WOODLAND HILLS SUBDIVISION, REMAINDER OF

APPLICATION NUMBER 21 DATE May 4, 2006
APPLICANT Woodland Hills Subdivision, Remainder Of
REQUEST Subdivision

DETAIL SITE PLAN

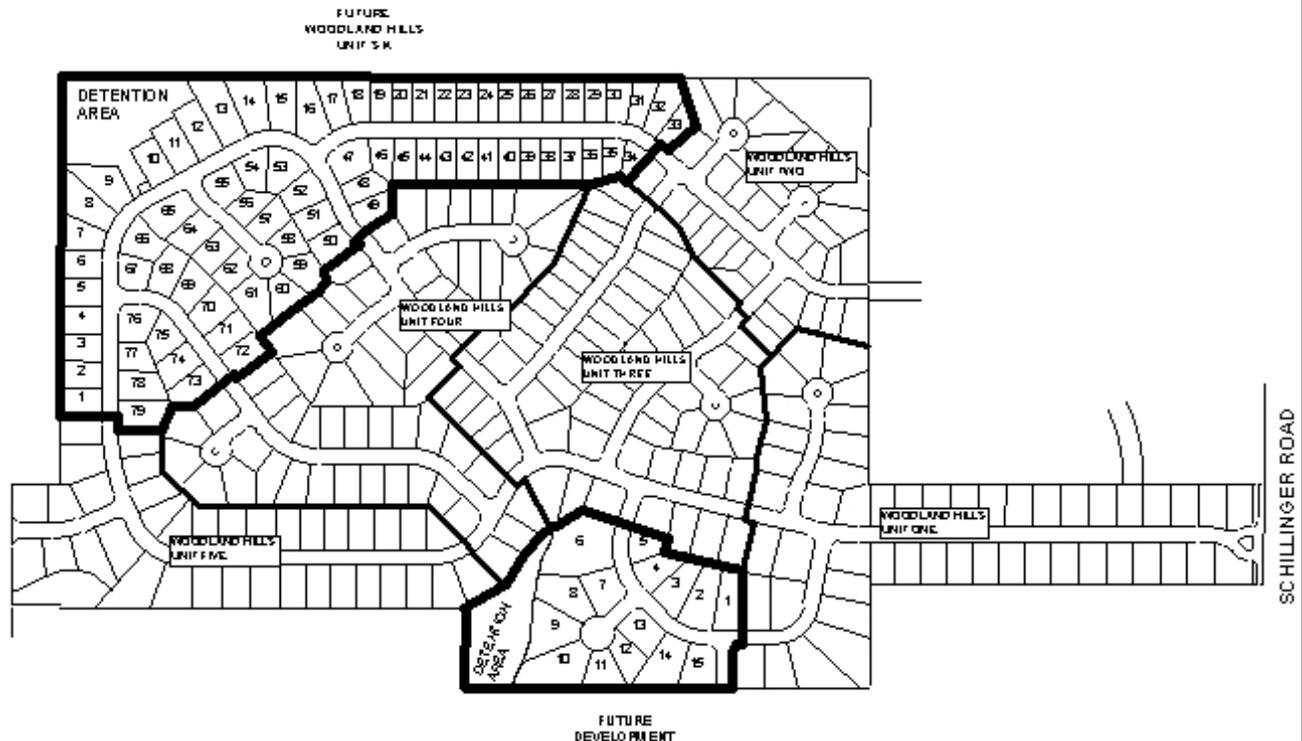
The preliminary plat under consideration depicts 94 lots, which includes the proposed 79-lot "Unit Six" of Woodland Hills, and a 15-lot area for "Future Development." Per the previously mentioned condition, the applicant would be required to construct and record the "Future Development" area either before or simultaneously with the proposed Unit Six in order to be in compliance with the condition. The land-locked property to the South remains land-locked, thus the condition still applies.

It should also be noted that at least one lot appears to be less that the minimum 7,200 square feet required by Section V.D.2. of the Subdivision Regulations. The plat should be revised to ensure that all lots meet the minimum requirements, or indicate that the proposed design is intended to comply with Section VIII.C. of the Regulations.

The area reserved for "Future Development" includes a detention area. The preliminary plat does not indicate a means of access to the detention area, therefore the plat should be revised to provide either an easement or dedicated access from a public right-of-way to the detention area.

The 25-foot minimum building setback line, required in Section V.D.9., is not shown for the subdivision, but would be required on the Final Plat, if approved.

The “Future Development” area includes a portion of Hamilton Creek, thus wetlands associated with the creek may occur on the site. The potential presence of wetlands indicates that the area may be environmentally sensitive; therefore, the approval of all applicable federal, state and local agencies would be required prior to the issuance of any permits or land disturbance.

Based on the preceding, the street-stub waiver request is Denied, but plat layout is recommended for Tentative Approval, subject to the following conditions: 1) the “future development” area must be developed before or simultaneously with the proposed “Unit Six,” with no recording of “Unit Six” allowed until the street-stub requirement is satisfied; 2) adjustment of lot lines to ensure that all lots meet the minimum size required by Section V.D.2. of the Subdivision Regulations; 3) provision of an easement or dedicated access to all proposed detention areas; 4) labeling of all common areas and detention areas; 5) placement of a note on the Final Plat stating that maintenance of the detention areas and common areas is the responsibility of the subdivision’s property owners; 6) depiction of the 25-foot minimum building setback line; 7) placement of a note on the Final Plat stating that any lots which are developed commercially and adjoin residentially developed property must provide a buffer, in compliance with Section V.A.7. of the Subdivision Regulations; and 8) the approval of all applicable federal, state and local agencies regarding wetlands prior to the issuance of any permits or land disturbance.
